VISITE DE CHANTIER 1

Villa Martin

Réalisation d'une maison en ossature bois

Phase de validation de la structure bois

ref: 1.3

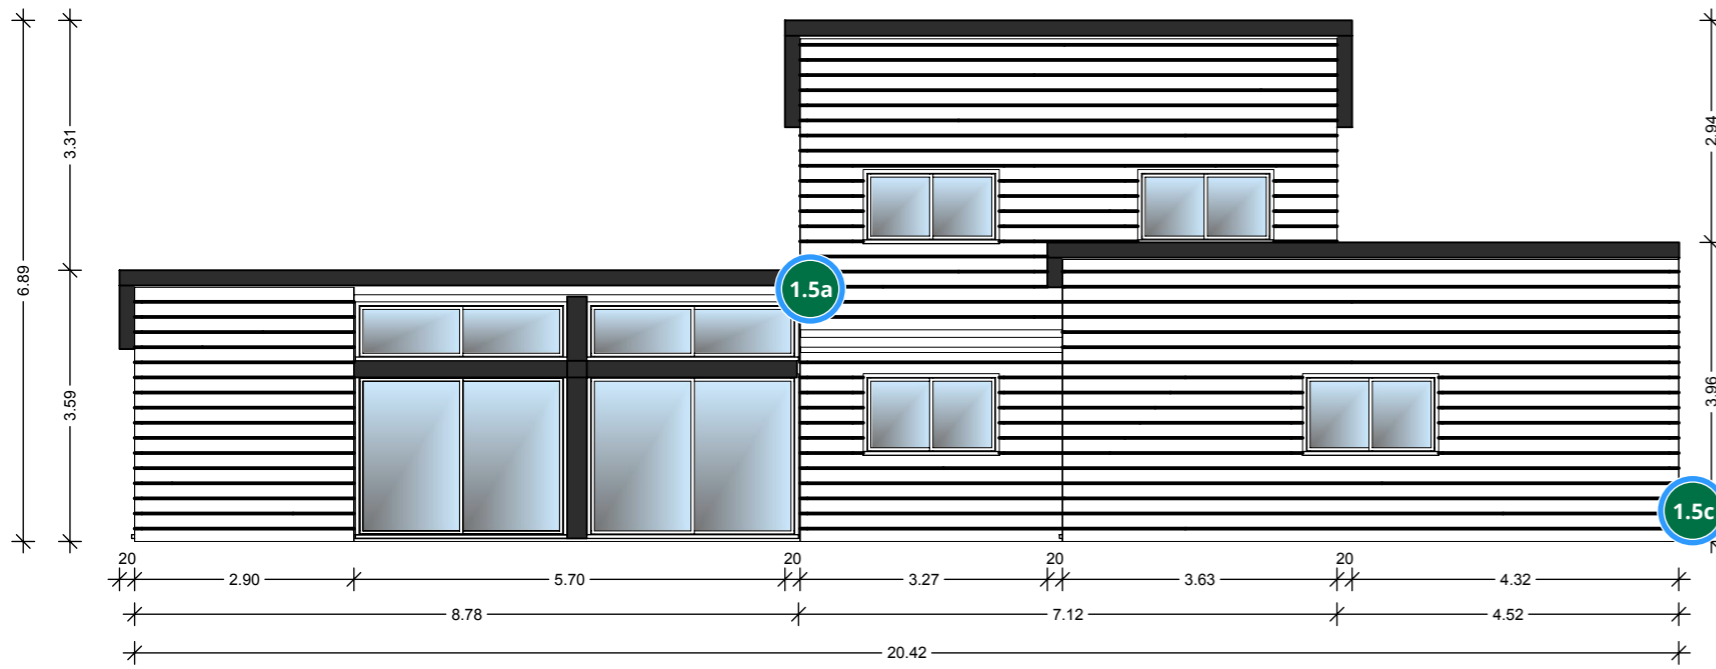
Il manque une poutre de renfort à l'entrée de la chambre
